Development Plans

0 Old Hickory Boulevard

Map 161, Parcel 90-07
 Nashville, Davidson Co., Tennessee
 Case No. 2022S-151-002

Nashville Department of Transportation
 And Mobility Infrastructure
EXCEPTION TAKEN AS NOTED
 This review does not relieve the applicant (s) from compliance with the rules, regulations, and specifications of this department and other governmental agencies. This check is only for general conformance with the requirements of the Nashville Department of Transportation.
 Christopher Gregory 08/21/2023
 Signed Date

Dale & Associates
 Civil Engineering & Land Surveying
 516 Heather Place
 Nashville, TN 37204
 (615) 297-5166
 D&A Project #20162
 0 Old Hickory Boulevard
C0.0

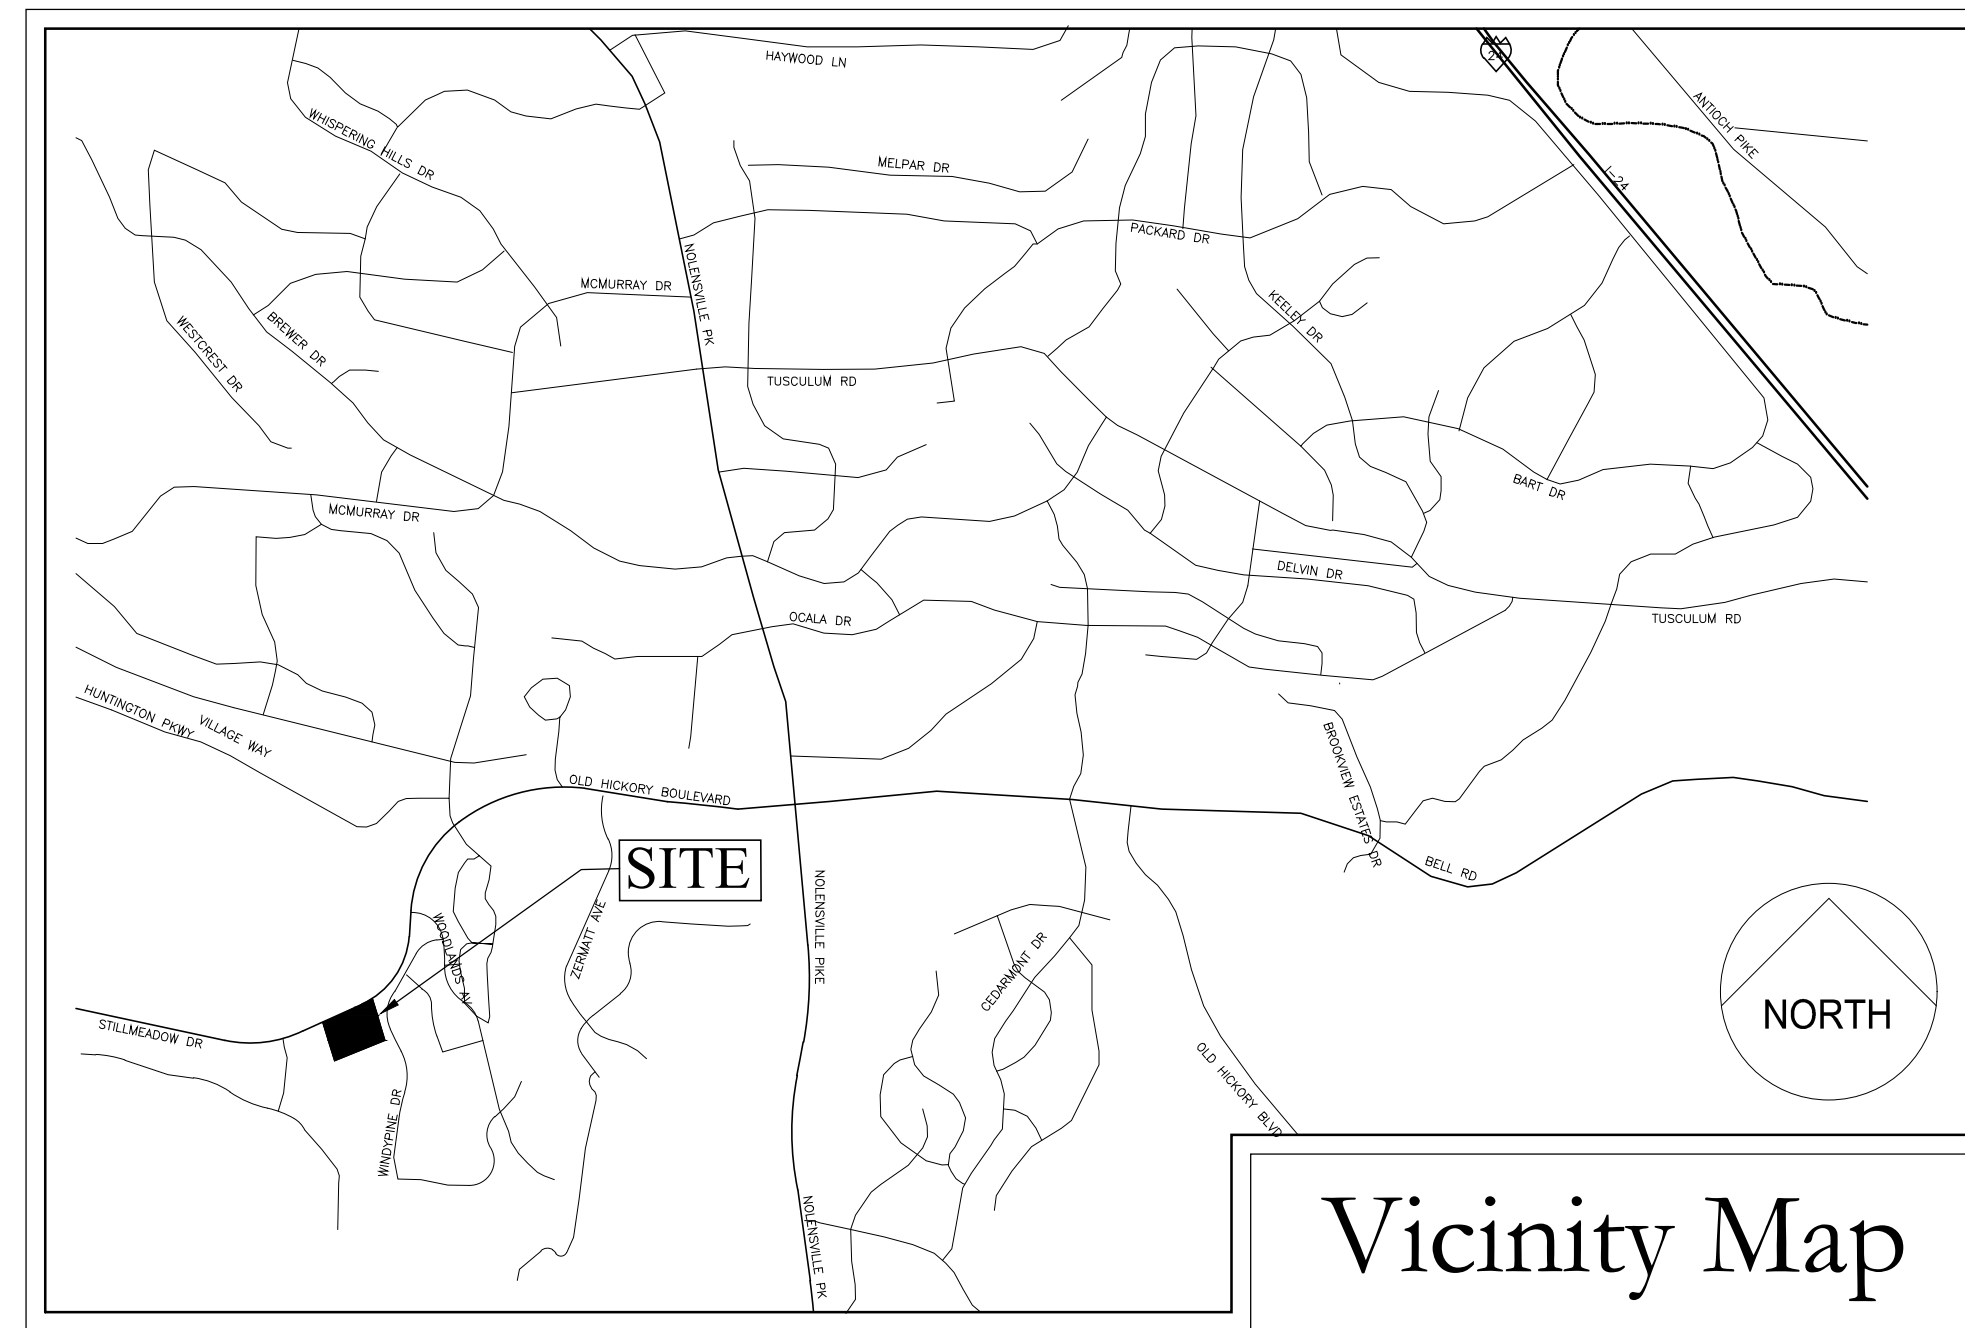
Confirm with Metro Nashville Waste Services on location of pickup. If cans are to be picked up after ROW within shared easement area a private hauler would be needed.

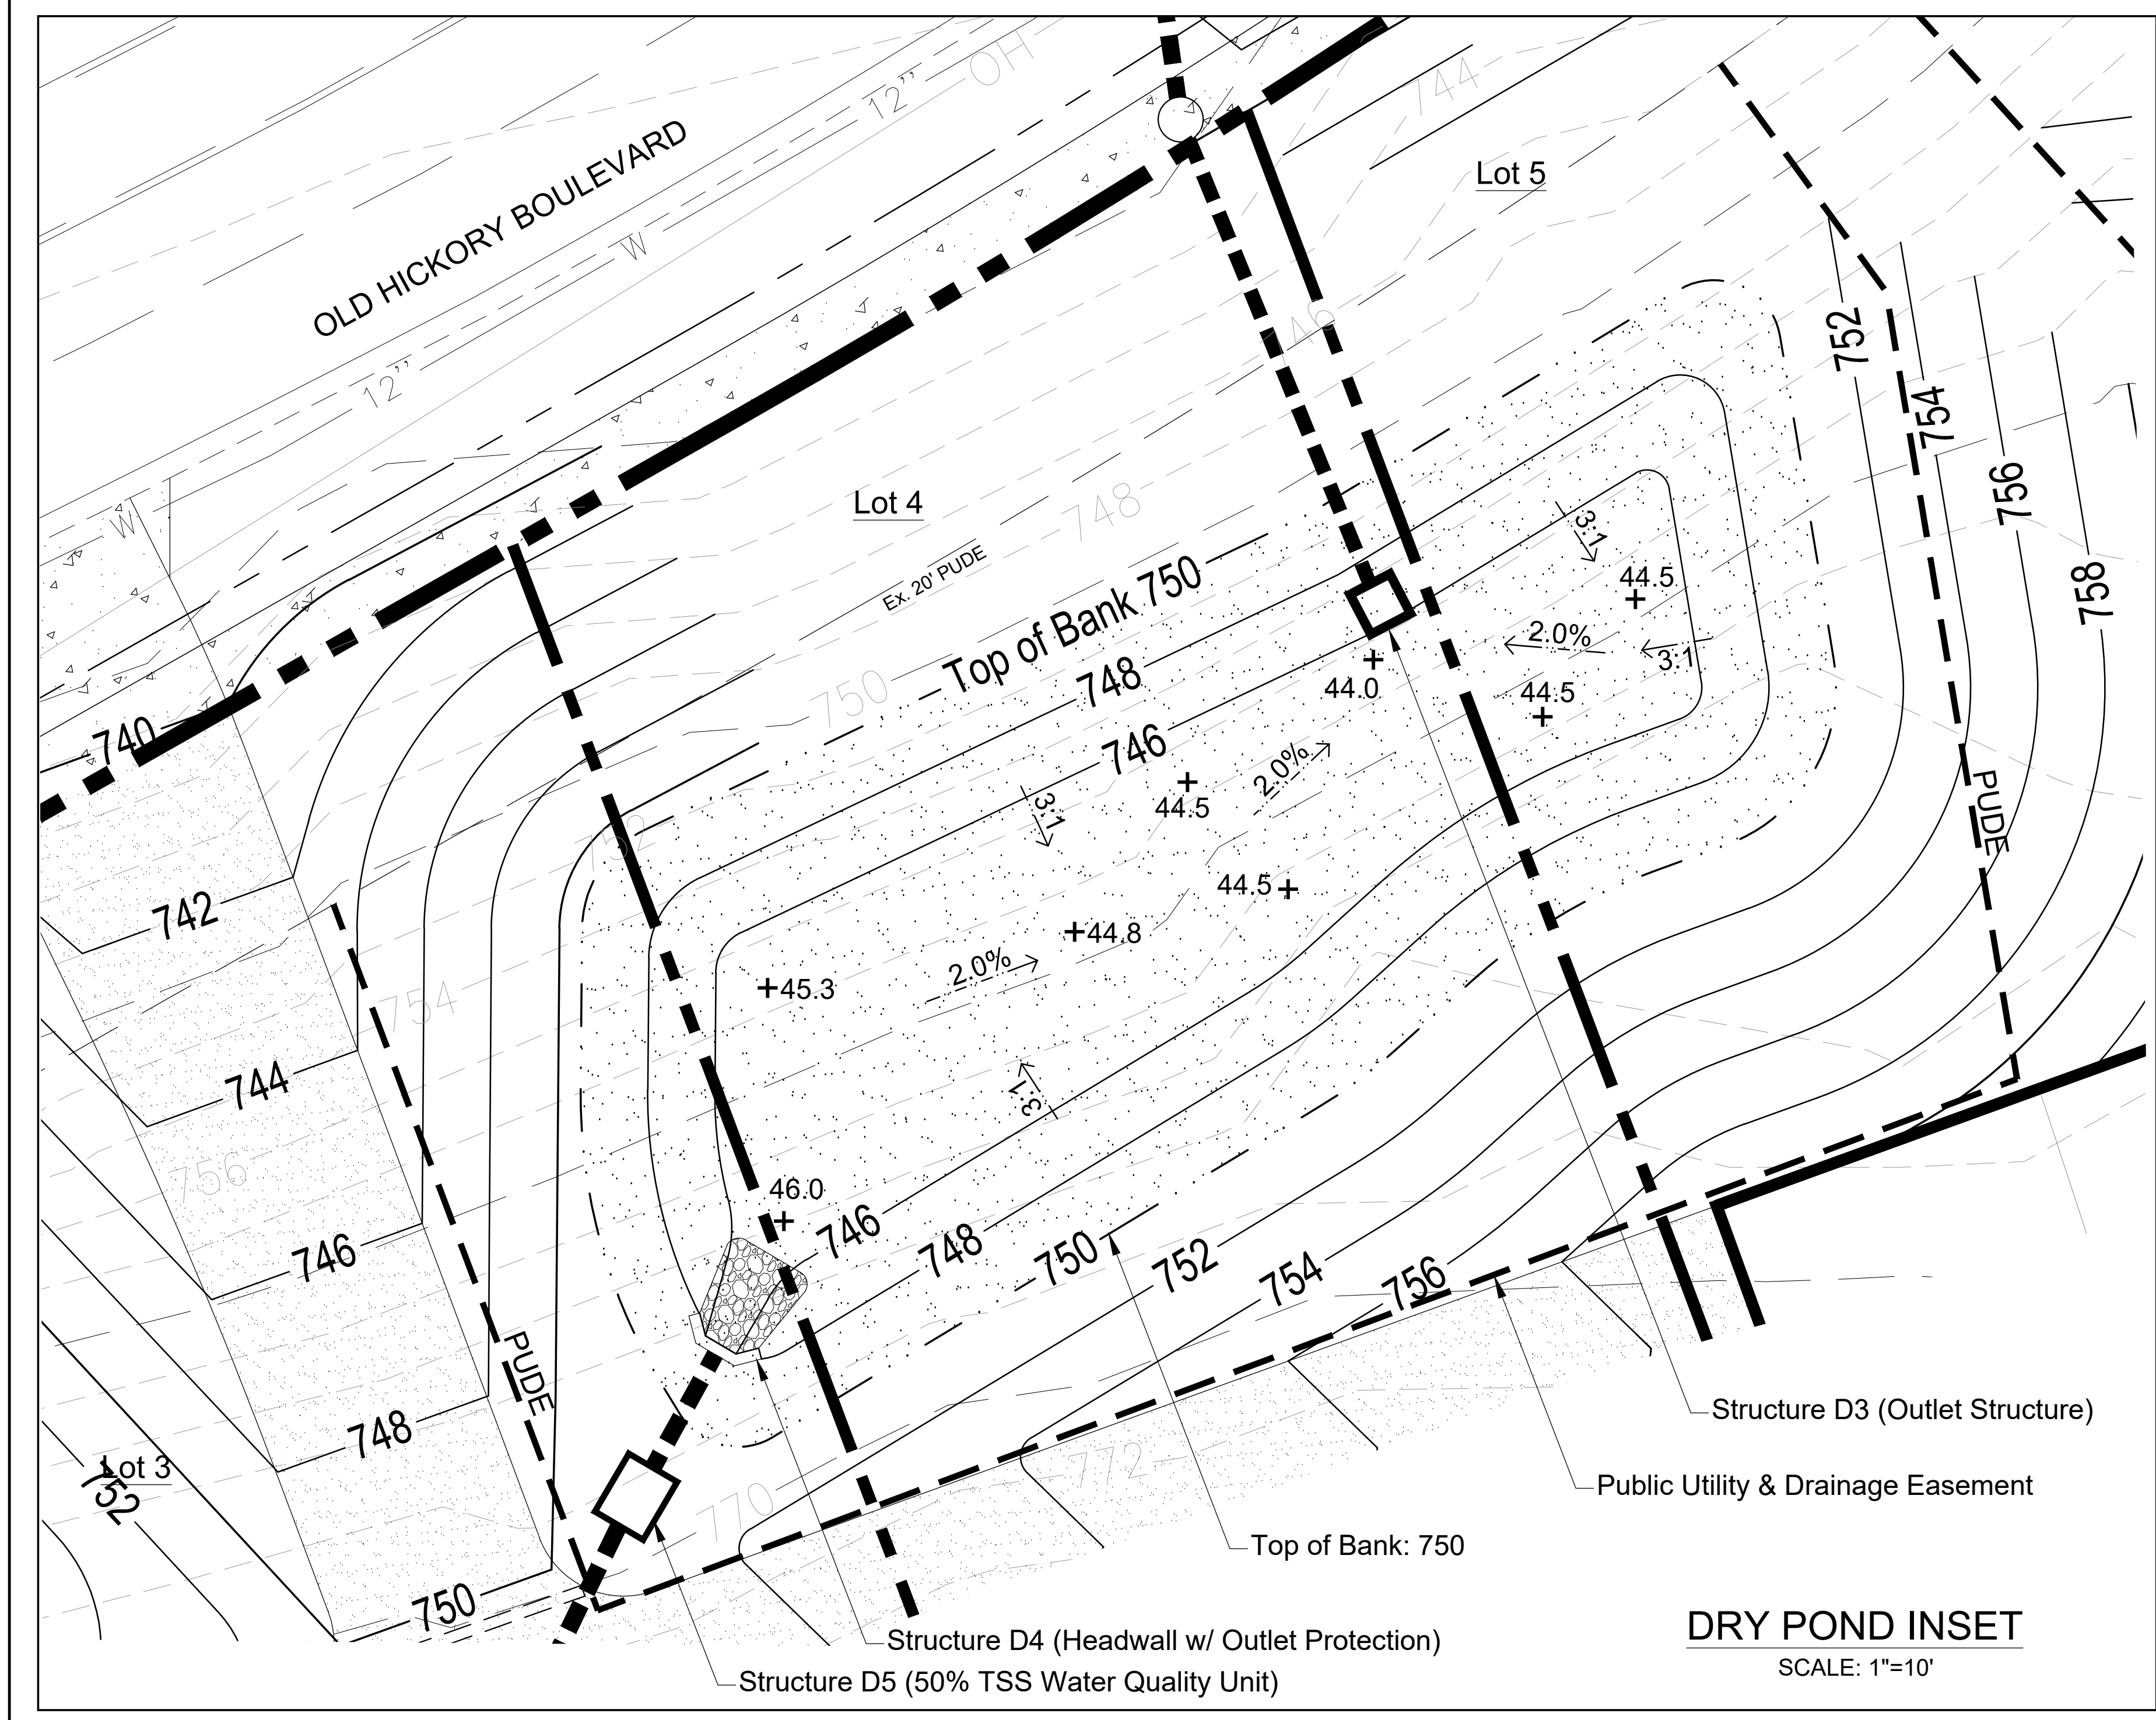
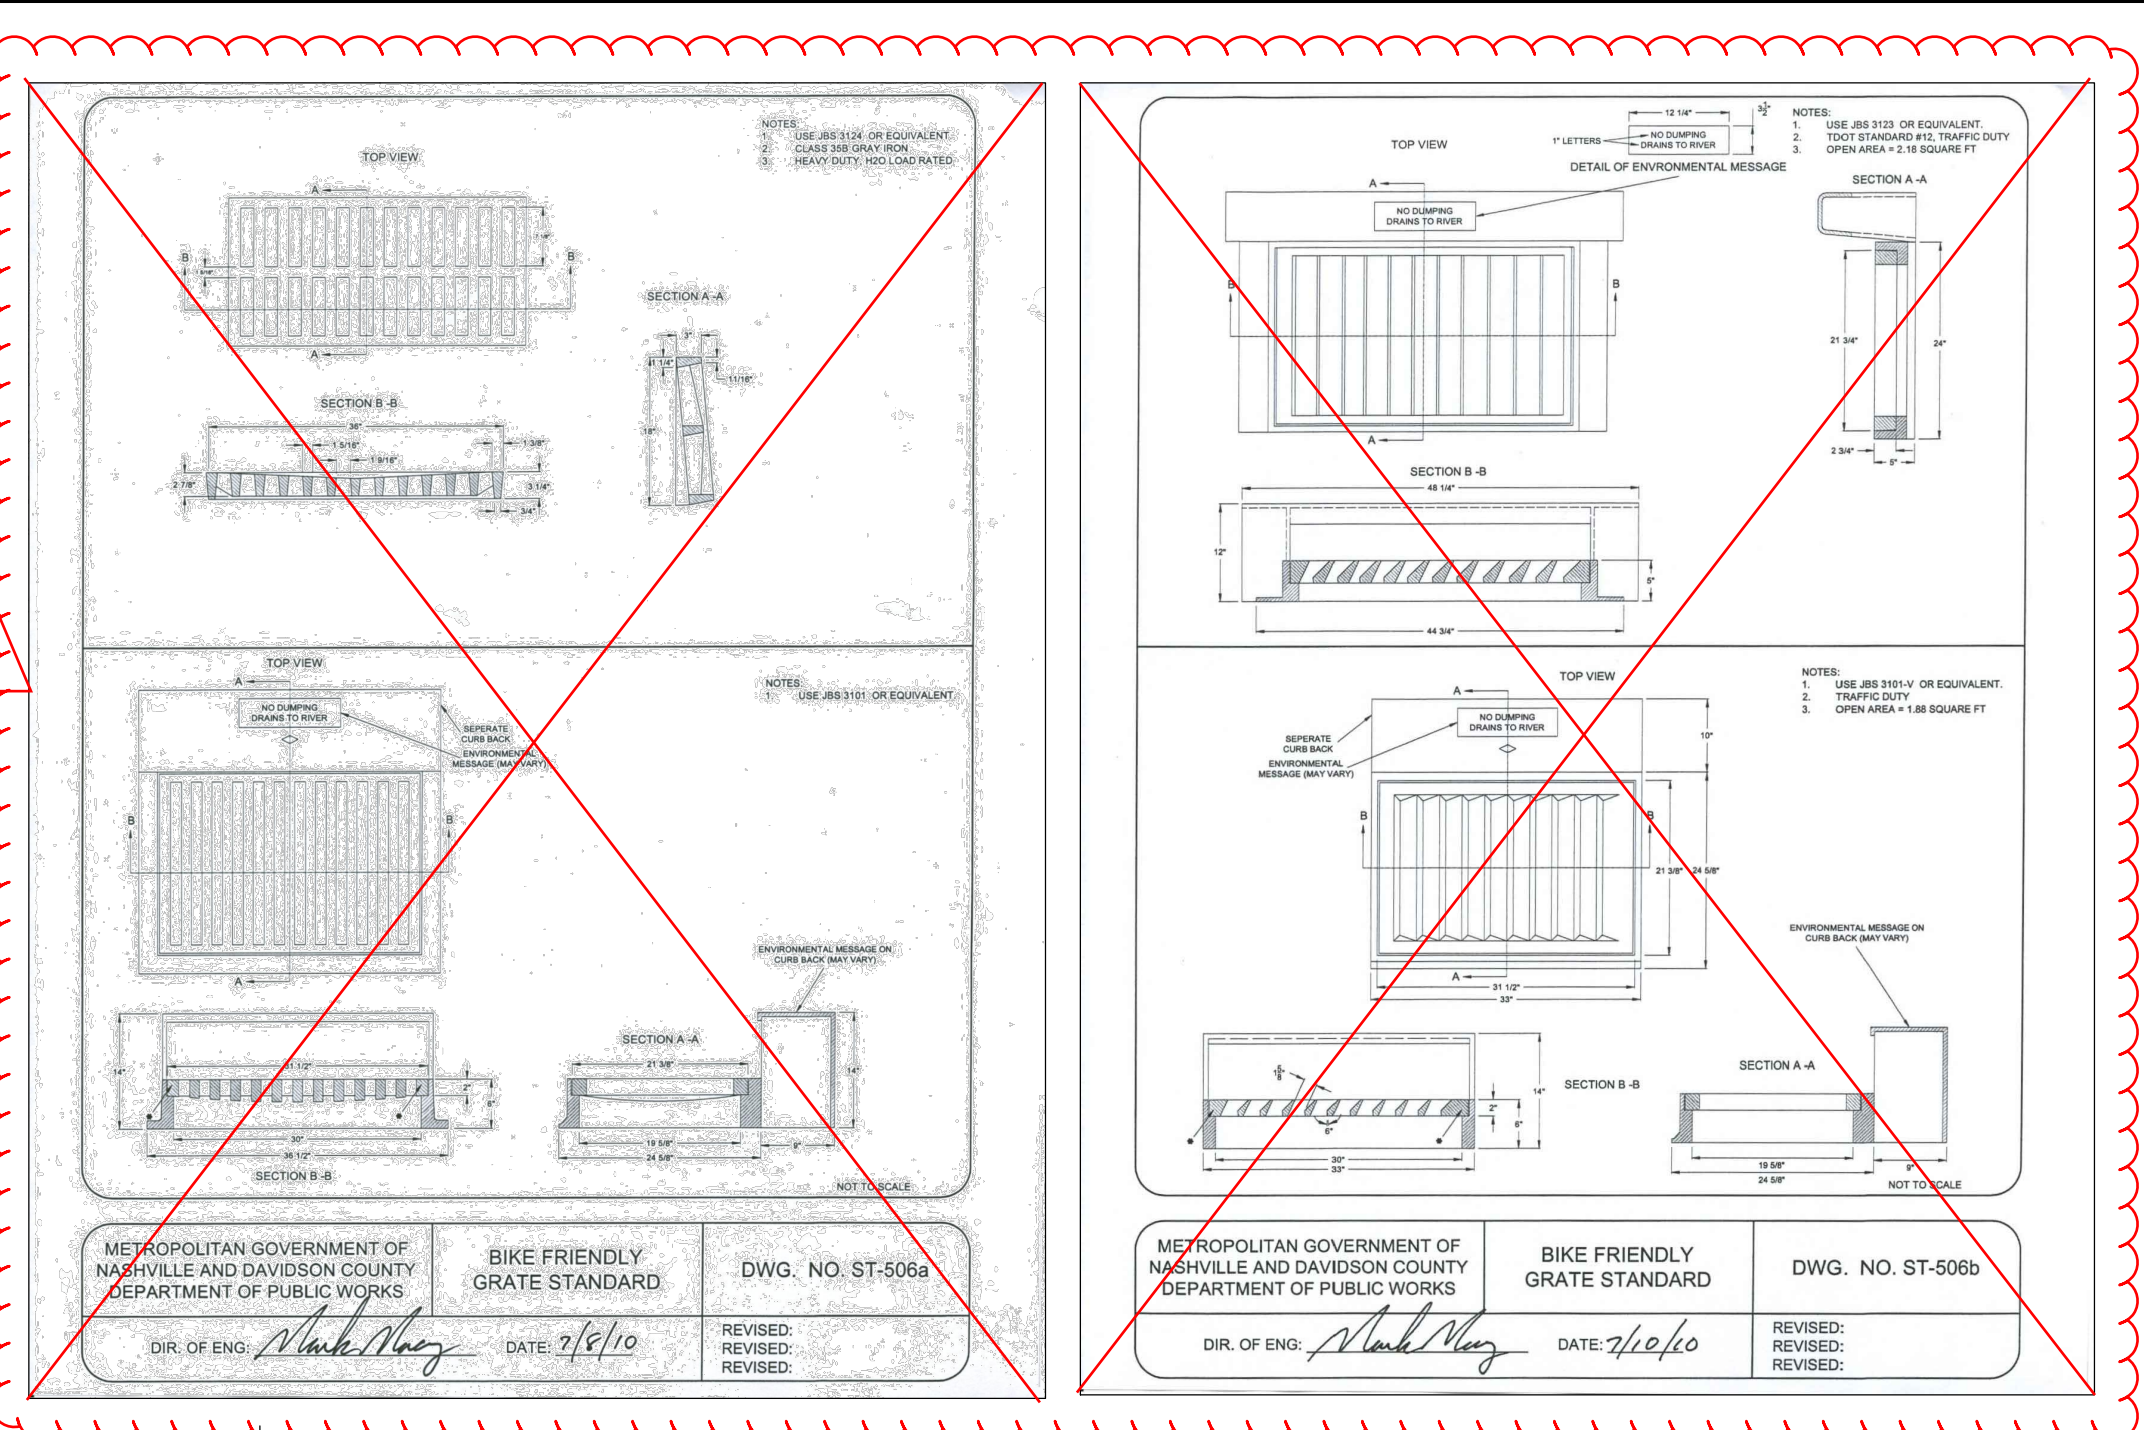
Use JBS 3300V bike friendly grate /w 6" hood. DO NOT use 9" hood. With road being state route 254, a TDOT equivalent may be used if required by the state.
